RESPONSE TO WDNR COMMENTS: REMEDIAL ACTION DESIGN REPORT
FORMER EZ PAINTR/SHUR-LINE FACILITY
4051 SOUTH IOWA AVENUE, ST. FRANCIS, WISCONSIN
WDNR BRRTS NO. 02-41-183146

WDNR *"REVIEW OF NR 724 REMEDIAL ACTION DESIGN REPORT"* LETTER (DECEMBER 19, 2024)

Subject: Review of *NR 724 Remedial Action Design Report*
EZ Paintr FMR – Shur Line Facility, 4051 South Iowa Avenue, St. Francis, WI
DNR BRRTS Activity #: 02-41-183146; FID #: 241501370

ERH SYSTEM LAYOUT

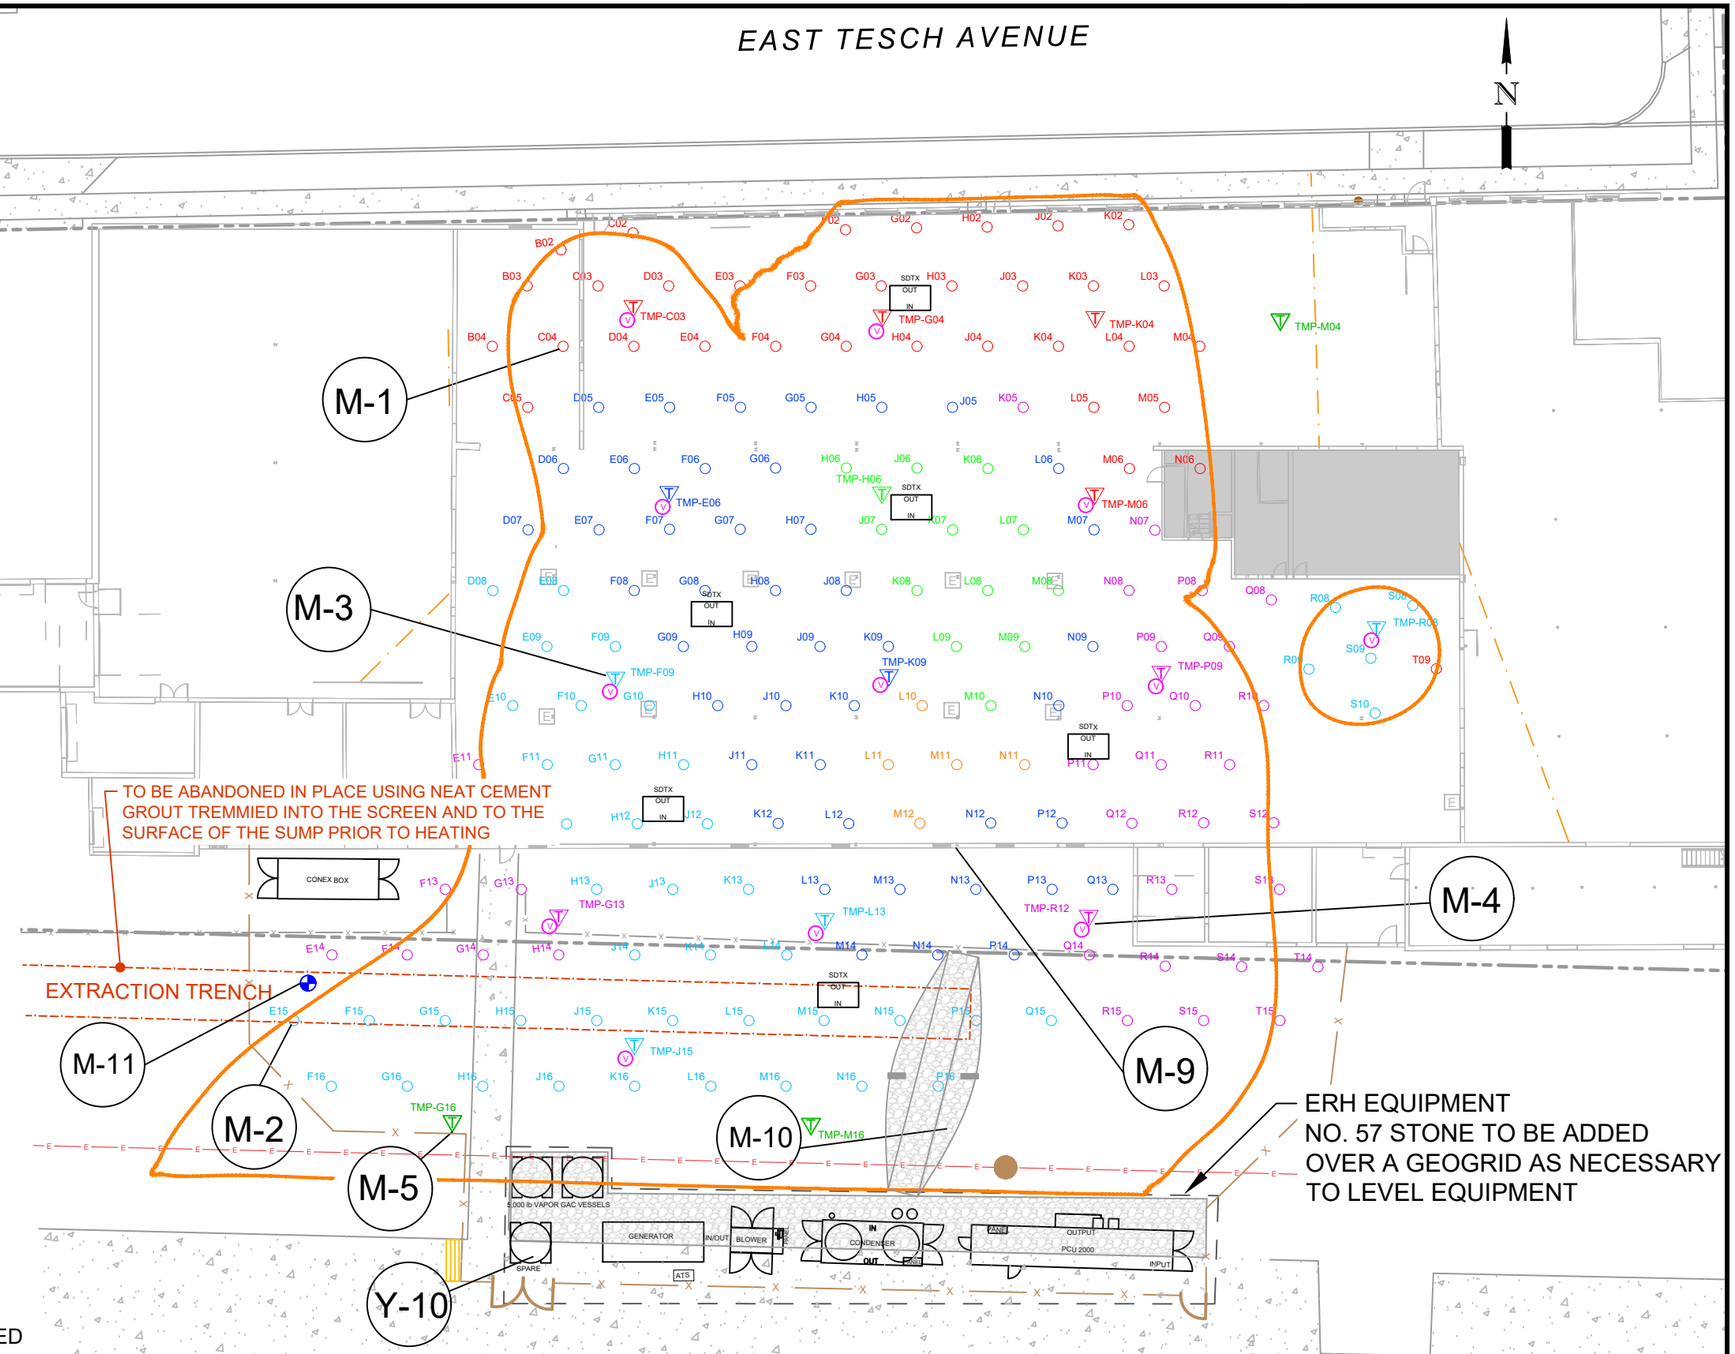
- Confirm temperature and vapor pressure monitoring points are positioned appropriately to ensure that utilities north of the building will not be impacted by the increases in temperature.
- Confirm the potential for spent carbon that will be taken offsite for recycling is a hazardous waste has been considered, and that the facility chosen for disposal of this material is equipped to recycle this waste.
- Sample MW-9, in addition to MW-13, MW-14, and MW-16, when periodically sampling groundwater while conducting the thermal treatment.

WDNR Requests	NOC Response
Confirm temperature and vapor pressure monitoring points are positioned appropriately to ensure that utilities north of the building will not be impacted by the increases in temperature.	The remediation vendor expects that temperatures will increase above ambient only within a distance of approximately 25 feet from the nearest electrode. Based on this expected radius of influence and electrode placement, the water, sewer, and gas lines along East Tesch Avenue will not be impacted. An additional temperature monitoring point (TMP-M04) will be installed between the remediation area and utilities that enter the north side of the building along East Tesch Avenue. The location of TMP-M04 is provided on the updated ERH layout figure (Drawing Y-2 in Appendix C of the RADR) in Attachment B.
